# ARB Board Order for Demolition

## 13-096ARB – BSC Historic Residential District

### 97 South Riverview Street

Re: Design Review for City of Dublin  
Schmitt Residence

SITE PLAN/ROOF PLAN

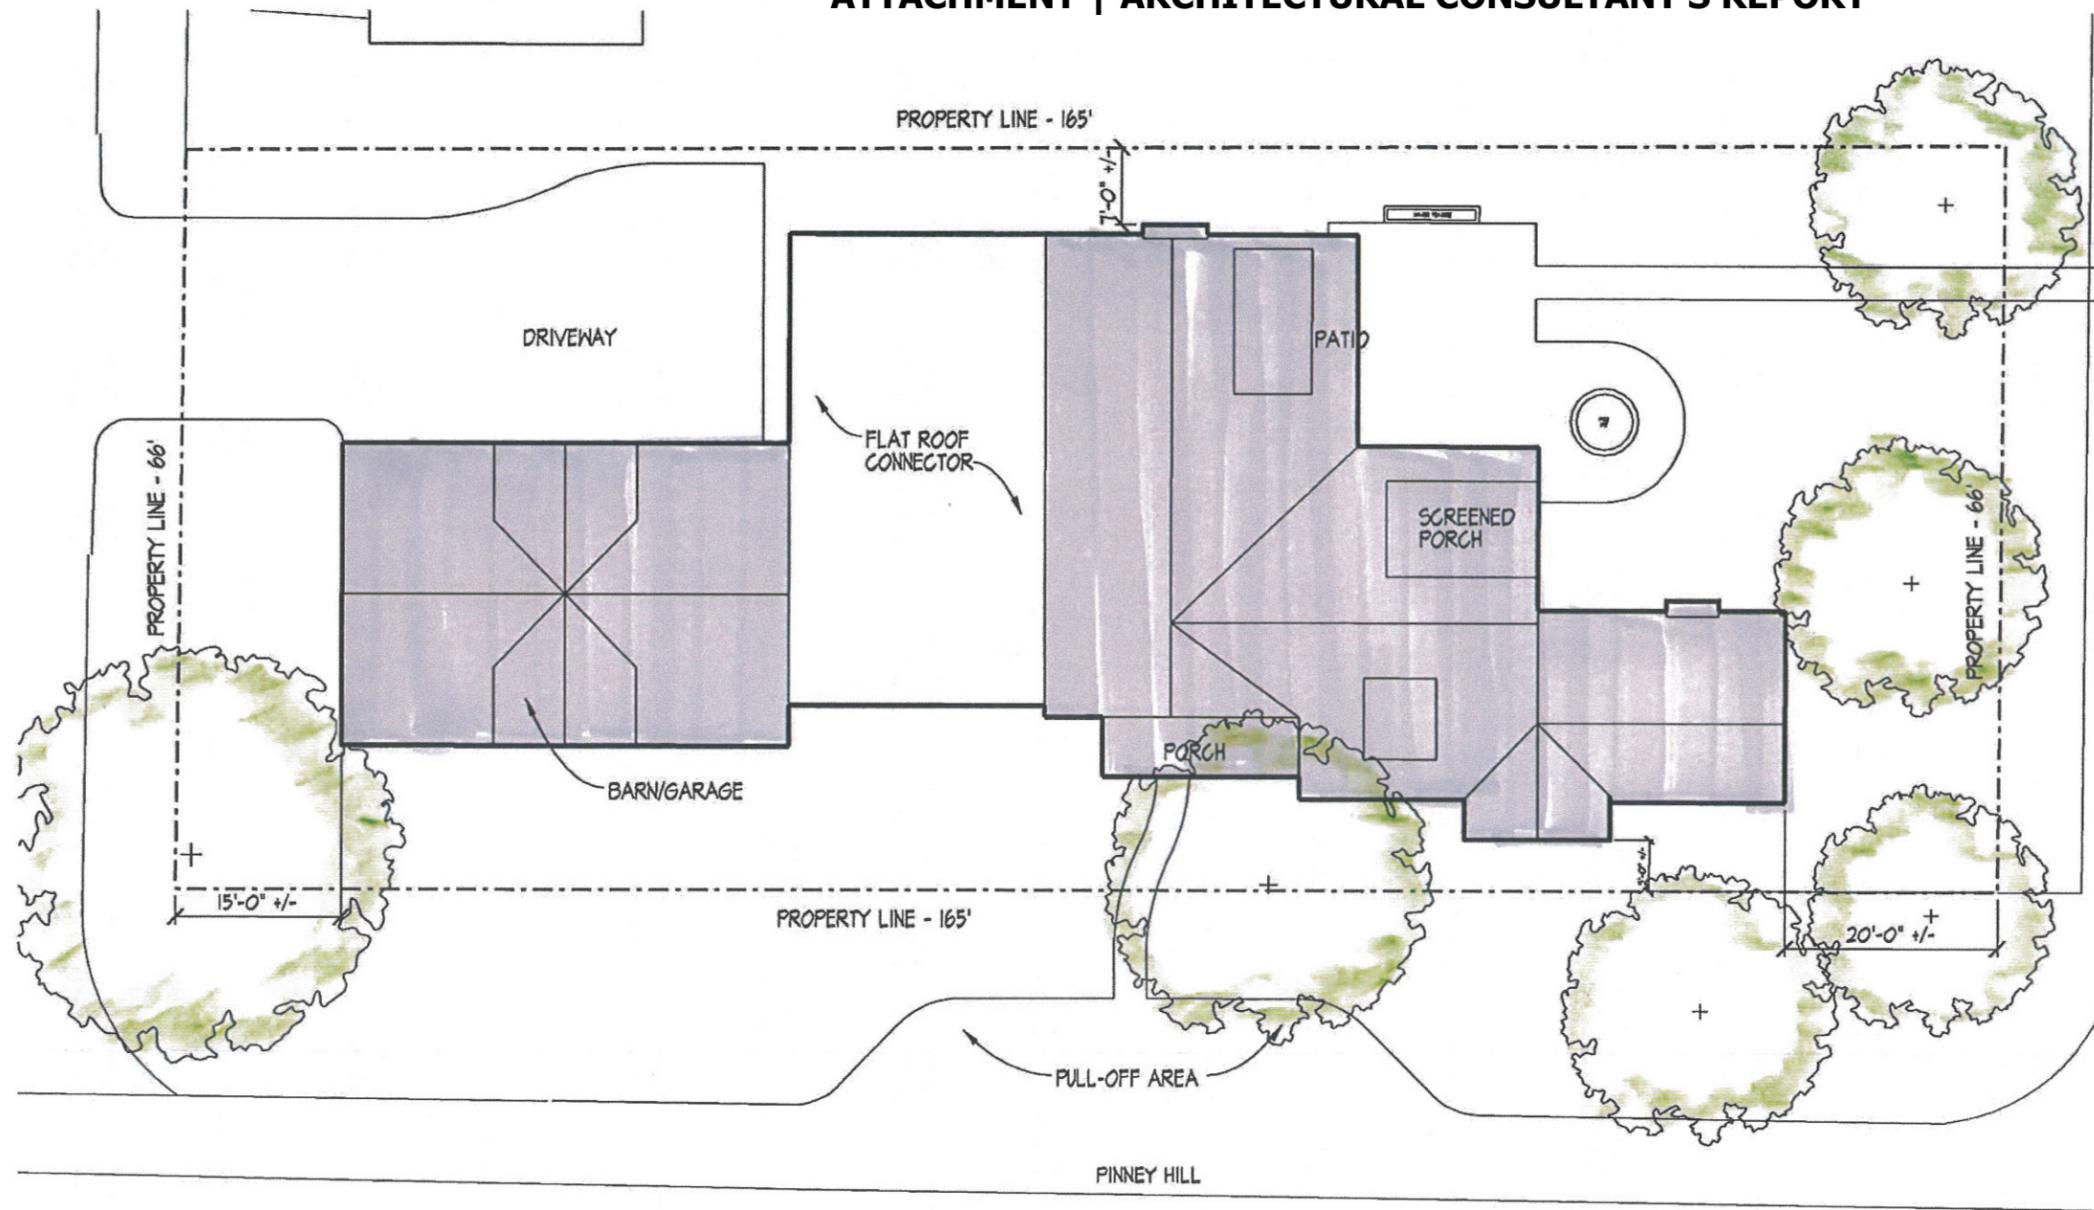
- 1) Providing the main entrance location off of Pinney Hill instead of South Riverview Street;
- 2) Balancing window placement;
- 3) Minimizing and/or redesigning the extensive flat roof portion of the connector between the home and the garage;
- 4) Minimizing the garage so that it does not diminish the massing of the principal structure; and
- 5) Thoughtful application of exterior building materials.

In addition to the preliminary comments outlined by the City's architectural consultant, Planning also recommends that the applicant modify the site plan to reduce the lot coverage below 50%, as required by the Zoning Code.

*PRINCIPAL FRONTAGE?*  
*IF SO, MAIN ENTRANCE REQUIRED.*

EAST ELEVATION

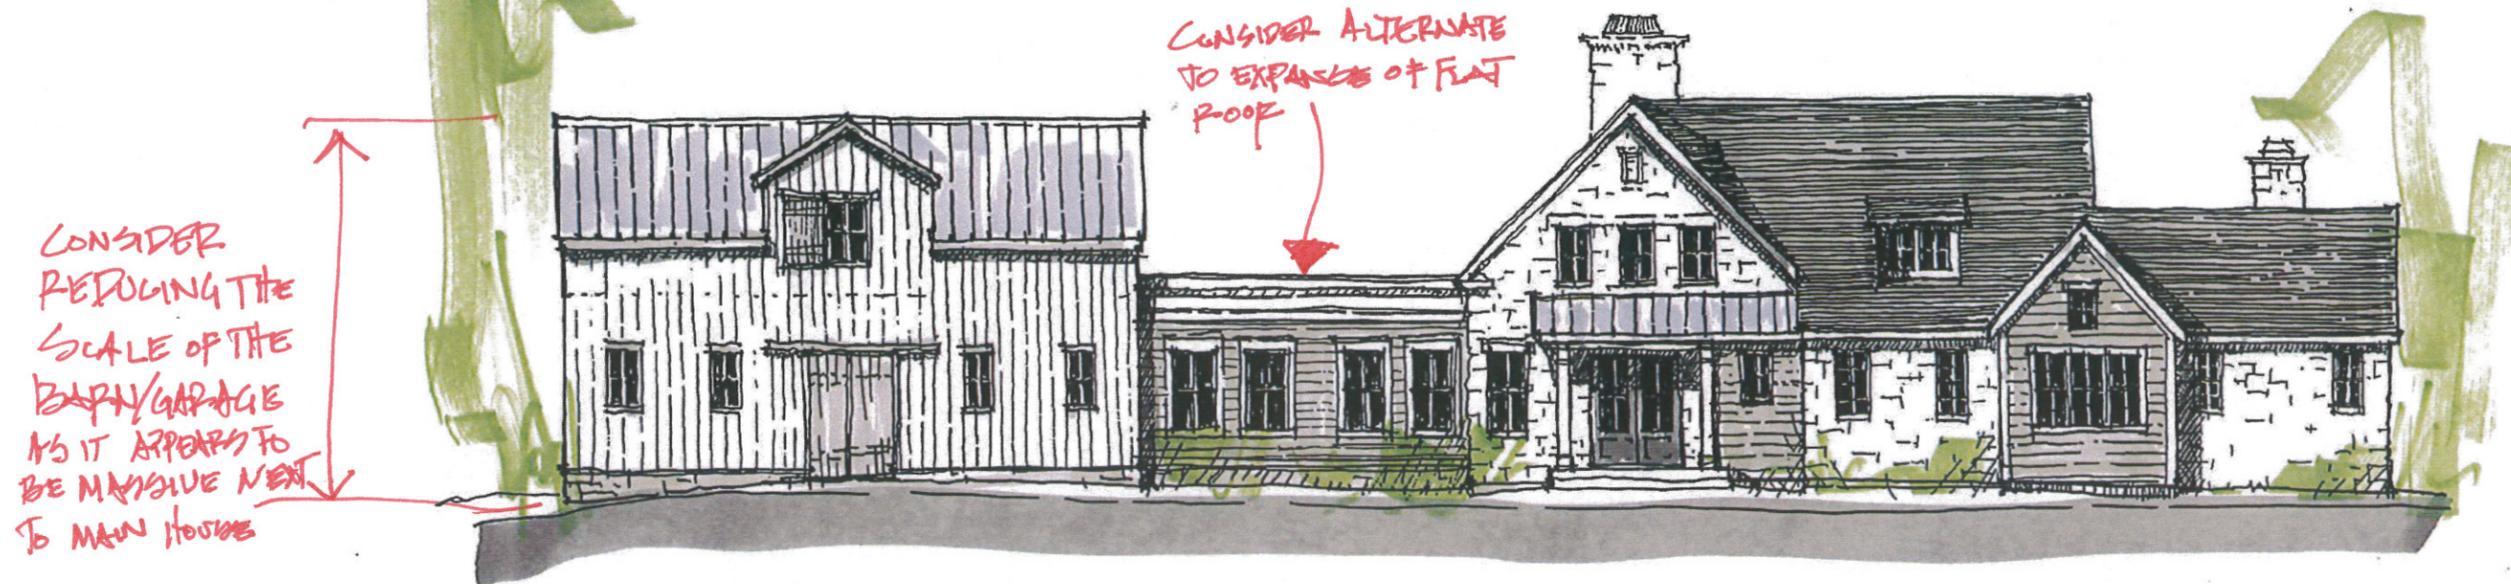
1. I have concerns whether the main entrance should come off of South Riverview in lieu of being accessed from Pinney Hill. It seems to me that maintaining the main entrance off of Riverview might be vital to the district.
2. The upper level windows on the east elevation appear inconsistent with the balance of the design. I would advise the applicant to redesign this area.
3. The flat roof connector as indicated on the south elevation appears out of scale in my opinion. I would suggest that the applicant consider an alternate design to this expanse of flat roof.
4. The Garage/barn element appears quite tall and massive adjacent to the house. I suggest that this element be scaled down so as not to diminish the main house.
5. Moving forward, we must understand the exterior materials.

EXTERIOR MATERIALS?
